SEPTIC SPECIFICATIONS WORK-SHEET

A 210163

STREET NAME: 5031 Morningstar Dr.

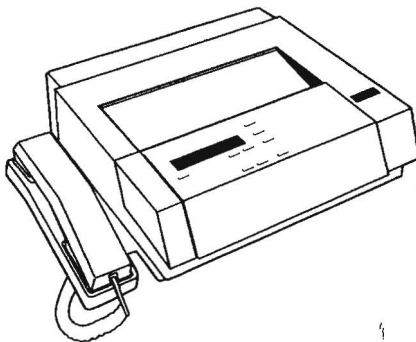
ADDITIONAL NOTES: In order to add 6th bedroom need to upgrade tank to 1750 gallon + pay \$165 permit fee

1750 gallon

two compartment tank
